SANTA MARGARITA PARKWAY BRIDGE

ABUTMENT DETAIL
NO. 1

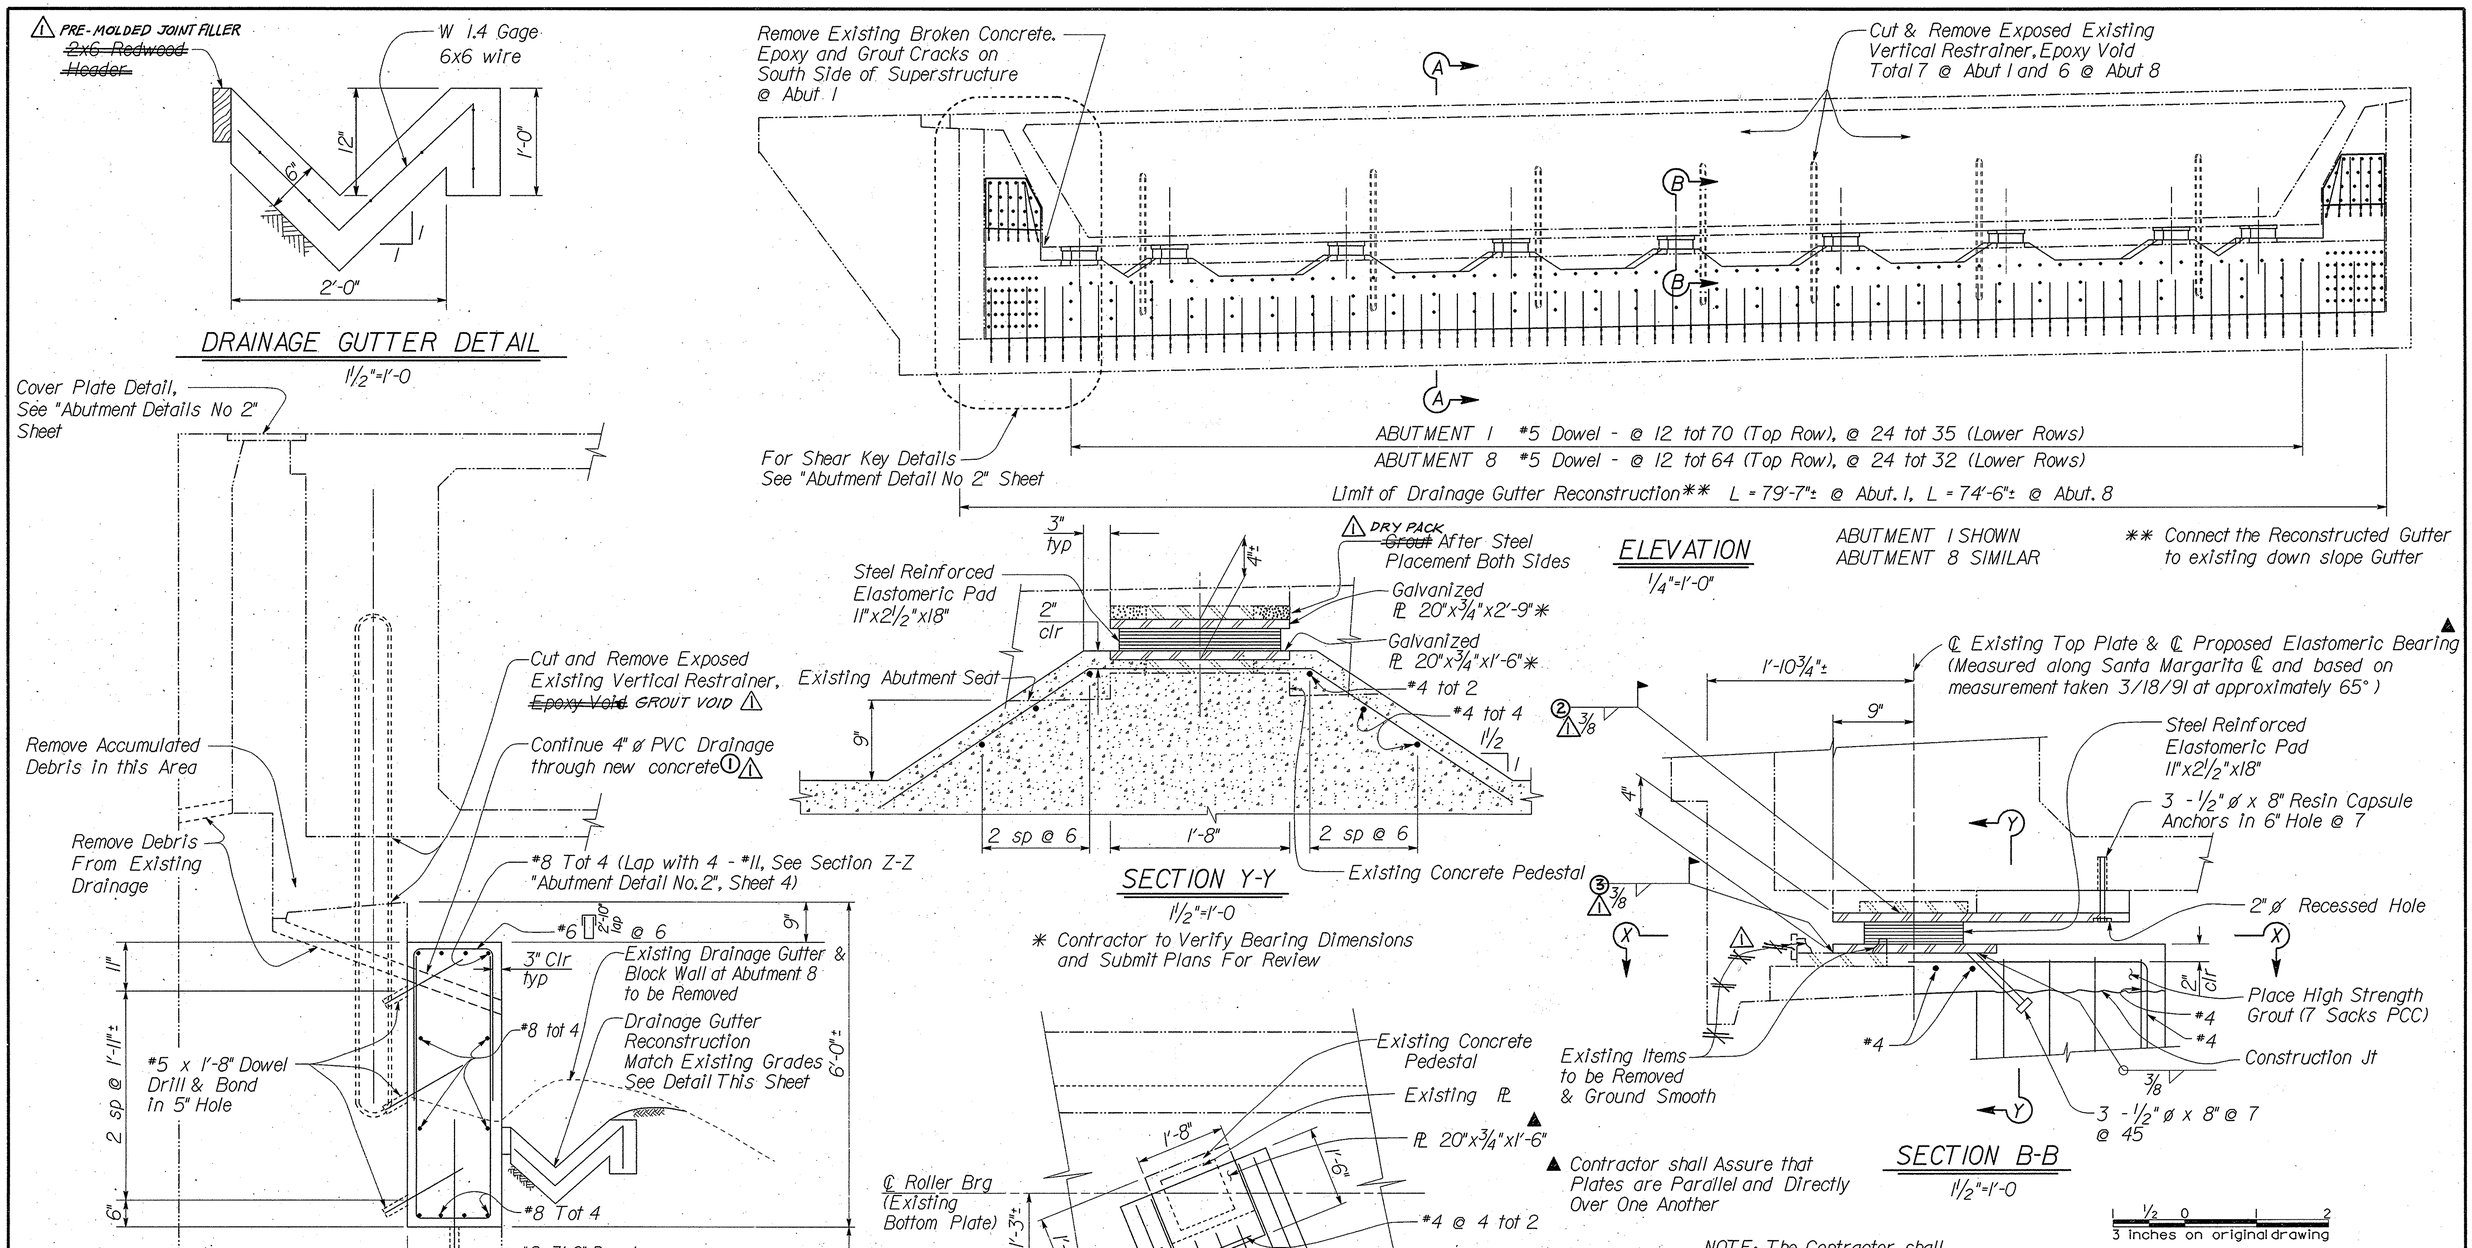
① ELIMINATE & GROUT FULL PVC PIPE @ WEST END OF ABUT #1, DUE TO INTERFERENCE WITH DENSE REBAR CONFIGURATION OF SECTION Z-Z, DWG #4

② WELD @ SIDES ONLY. WHERE FAR SIDE OF PLATE IS INACCESSABLE, WELD ALONG FRONT OF PLATE TO MAKE UP THE DIFFERENCE.

③ WELD @ SIDES ONLY, PARTIAL LENGTH, APPROX. 6" TO 9" EACH SIDE.

▲ Contractor shall Assure that Plates are Parallel and Directly Over One Another
